Version 6

A/C Does Not Blow Cold Air and Condenser Leaks at Receiver Dryer Cap

Supersedes 18-080, dated July 16, 2019, to revise the information highlighted in **yellow**

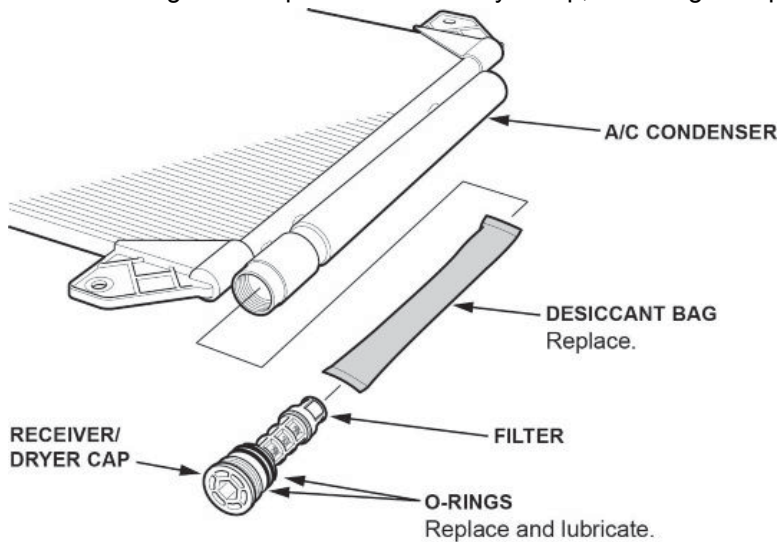
Check if the A/C is blowing cold air and there is staining around the receiver dryer cap on the condenser.

- If the A/C is not blowing cold air and there is staining around the receiver dryer cap on the condenser, go to REPAIR PROCEDURE.
- If the A/C is not blowing cold air and there is no staining around the receiver dryer cap, continue with normal system troubleshooting.
